DEVELOPMENT SERVICES

DESIGN REVIEW BOARD VALLEY VIEW TERRACE TOWNHOMES PHASES 6 AND 7 Case 2020-MSS-BRD-00002

AGENDA ITEM: 6.1 Valley View Terrace Request for Design Review

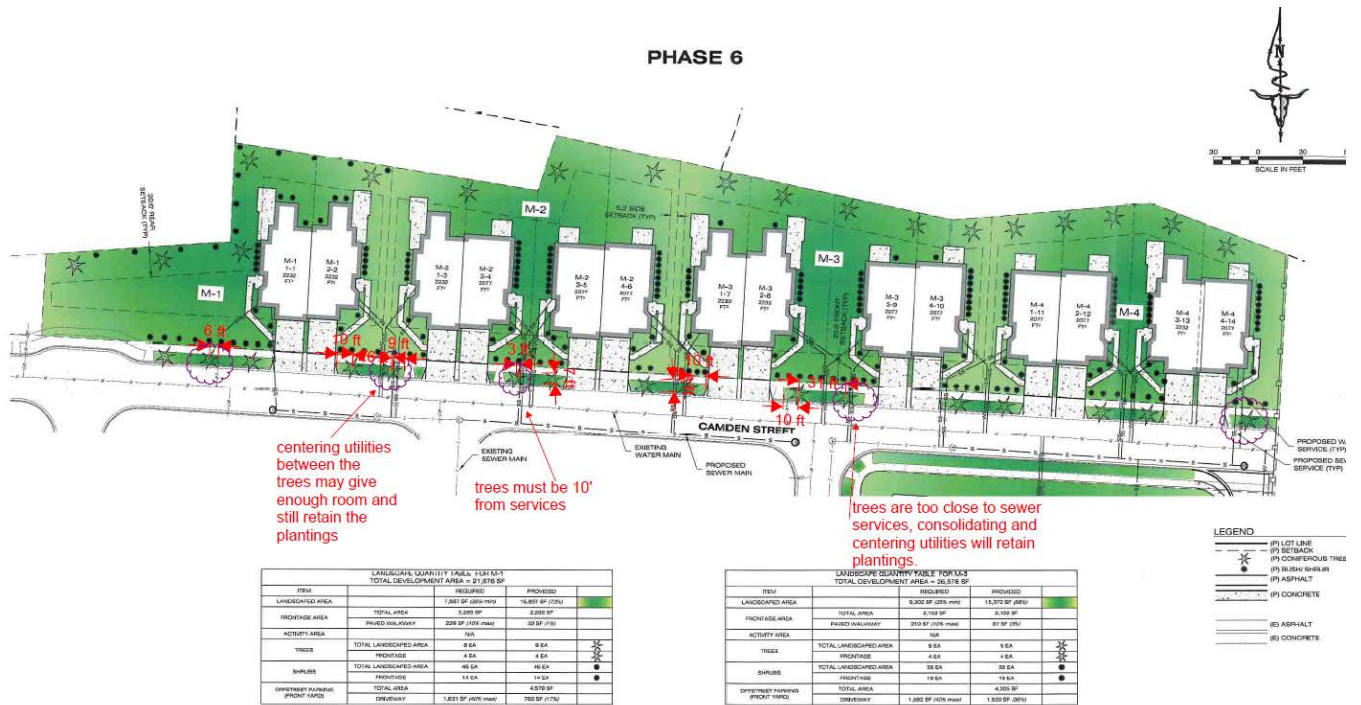
Parks & Recreation Department's comments and edits below – see also marked up landscape plans.

- There are some service lines that cross the boulevards, that could be consolidated and centered to retain tree plantings. Also, the lateral distance to service lines needs to be maintained at a minimum of 10', Page 6 of 10.
- Tree placement and spacing on Manchester and Camber are acceptable, page 7 of 10.
- Tree placement needs to be retained at a minimum lateral distance of 10' from driveway and sidewalk ramps. In order to maintain the tree count and accommodate this requirement, the tree spacing may be reduced to 20' and if needed up to 15' with the appropriate class one tree species selected.
- Once the plant schedule is submitted, review and potential approval will be based on the above conditions and species selections.

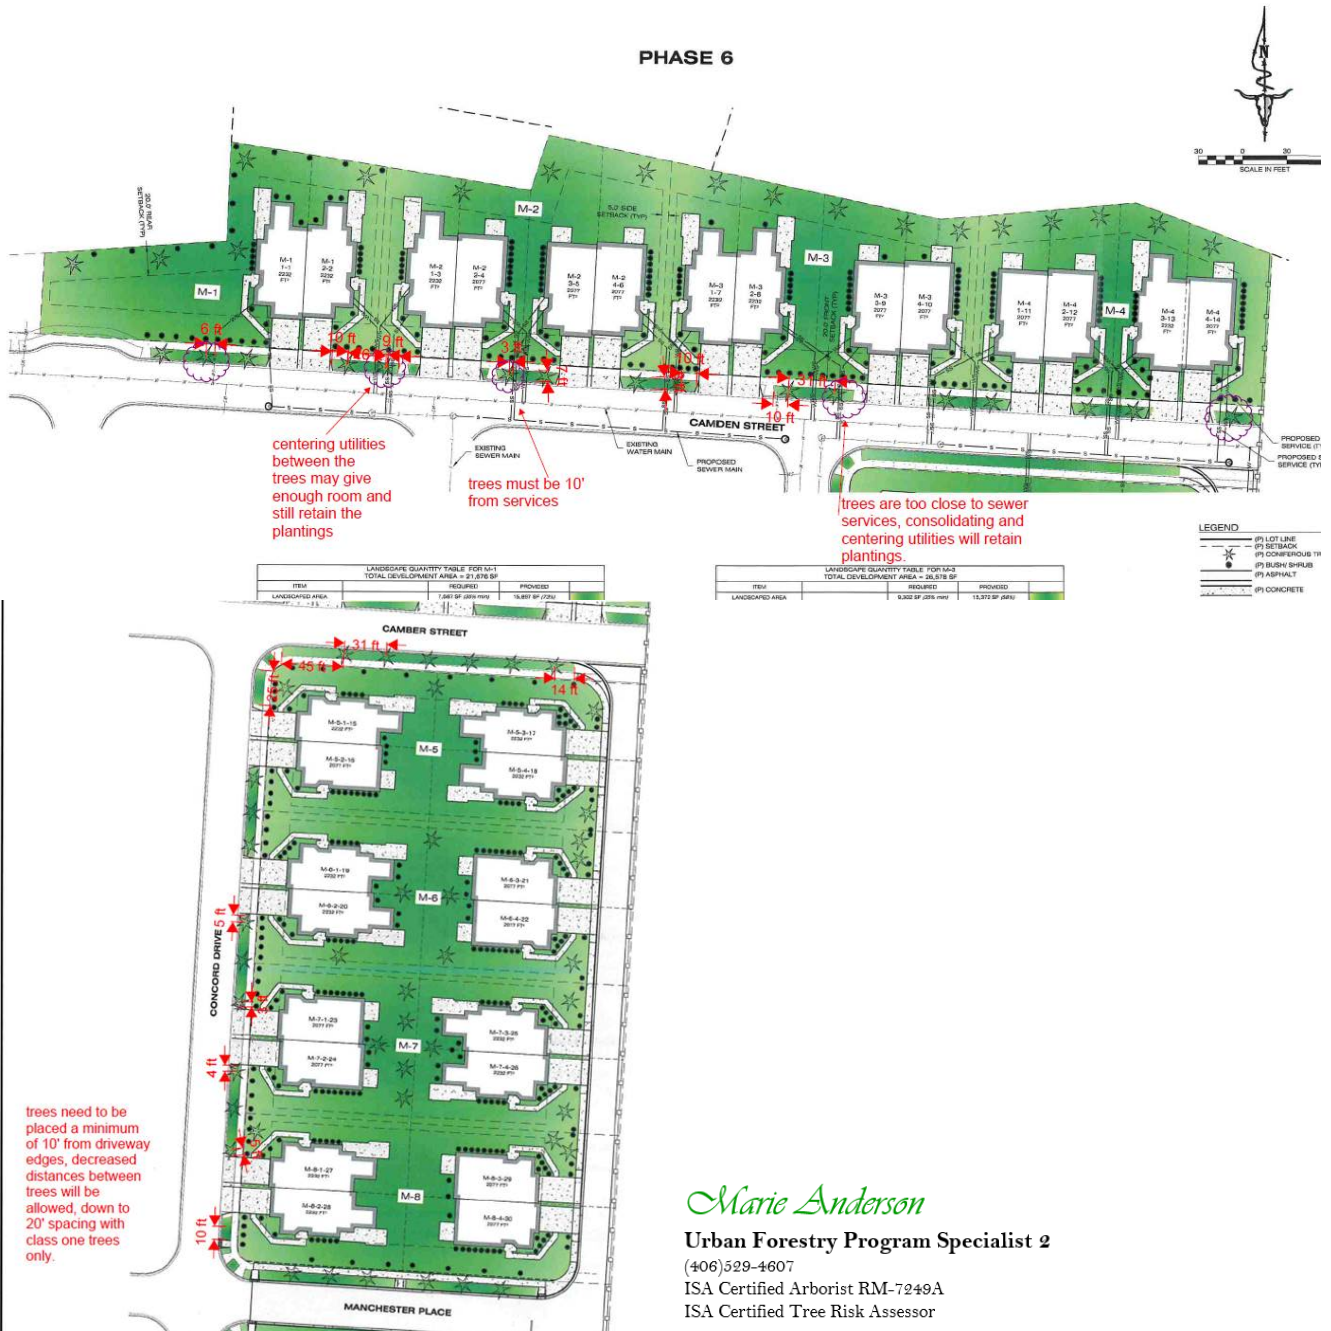
Parks & Rec Department comments below including mark-up edits on the landscape plans.

- There are some service lines that cross the boulevards, that could be consolidated and centered to retain tree plantings. Also, the lateral distance to service lines needs to be maintained at a minimum of 10', see below site plan **mark-ups**
- Tree placement and spacing on Manchester and Camber are generally acceptable, but some modifications are noted - see below site plan **mark-ups**
- Tree placement needs to be retained at a minimum lateral distance of 10' from driveway and sidewalk ramps. In order to maintain the tree count and accommodate this requirement, the tree spacing may be reduced to 20' and if needed up to 15' with the appropriate class one tree species selected. see below site plan **mark-ups**
- Once the plant schedule is submitted, review and potential approval will be based on the above conditions and species selections.
